Proof of Publication - Notice of Intent to Issue Air Construction Permit, DRAFT Permit No.: 0570008-013-AC (PSD-FL-234)

Animal Feed Ingredient Plants at Cargill Fertilizer, Inc.'s facility located at 8813 U.S. Highway 41 South,, Riverview, FL 33569,

Animal Feed Plant - Draft Permit 0570008-013-AC (PSD-FL-234)

Animal Feed Plant - Revised Draft Permit 0570008-013-AC (PSD-FL-234)

Table 1. Calculation of Fluoride Emissions From AFI Plant Defluorination Area

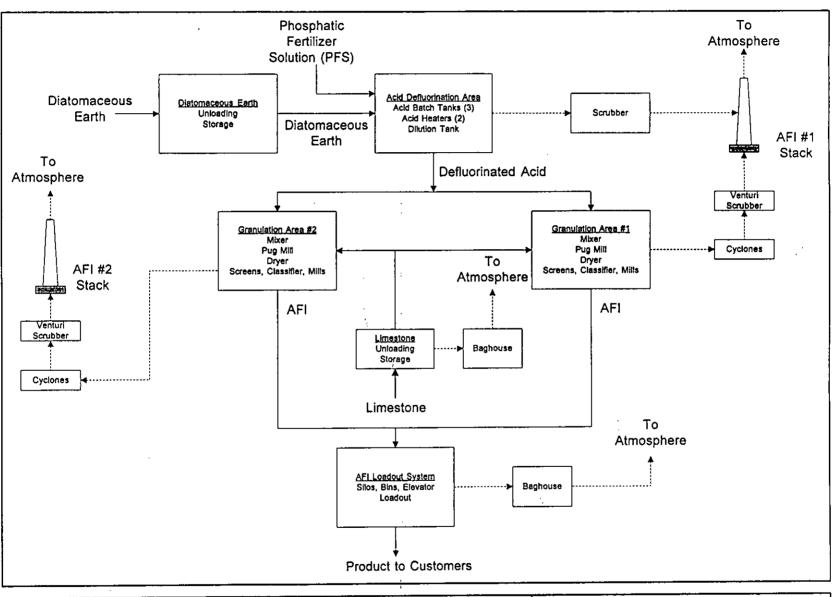
- 2. The calculations in Table 1 are based on one batch tank, but the resulting emissions are then doubled to represent two batch tanks operating. As discussed in Item 1 above, the existing scrubber is designed to accommodate one batch tank, and has 8 NTUs. The modified scrubber will be designed to accommodate two batch tanks with the same NTUs. For permitting purposes, we have estimated emissions for the worst case situation, which is to assume that only one batch tank is operating at any one time, but then doubling the emissions to account for two batch tanks.

Section 6.1, pg. 8 - The emission summary table incorrectly lists the new allowable for fluorides from the common stack to be 0.53 lb/hr instead of 7.7 lbs/batch. However, Table 1 of the draft permit is correct.

Based on information from the scrubber vendor, KEMWorks Technology, Inc., the following calculations are provided showing the scrubber capabilities and estimating the evolution of fluorine during the batch process. Typical worst-case conditions are estimated in order to provide the typical worst-case emissions.

In the initial permit application the batch time was estimated to be 17 hours. However, since startup, it has been found that actual batch times vary and it can take longer than 30 hours to achieve the necessary fluorine removal. On an annual basis, the average batch time is not expected to exceed 30 hours. Approximately 91 percent of the fluoride evolution from the batch tank occurs during the first 5 hours after the diatomaceous earth has been added to the batch, with the remaining 9 percent being evolved over the remaining hours of the batch.

Figure 2-1 Animal Feed Plant Process Flow Diagram

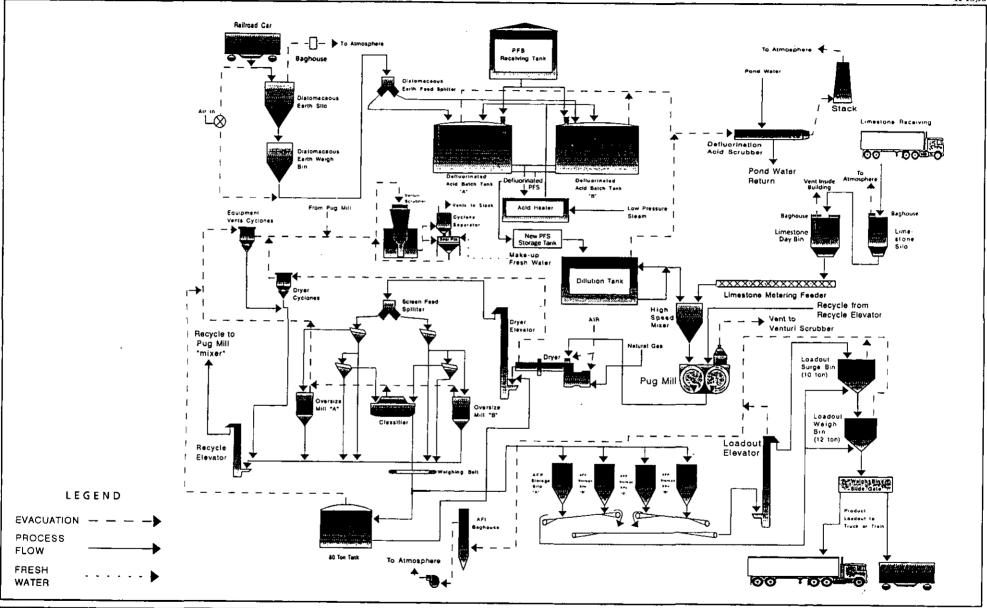
In addition, a new defluorinated acid storage tank will be added to each AFI plant to store defluorinated acid from the two batch tanks within each plant. A revised flow diagram showing the new tank within one of the AFI plants is attached. The granulation area, limestone handling, and product storage, handling and loadout portions of the plant will not be affected by this change.
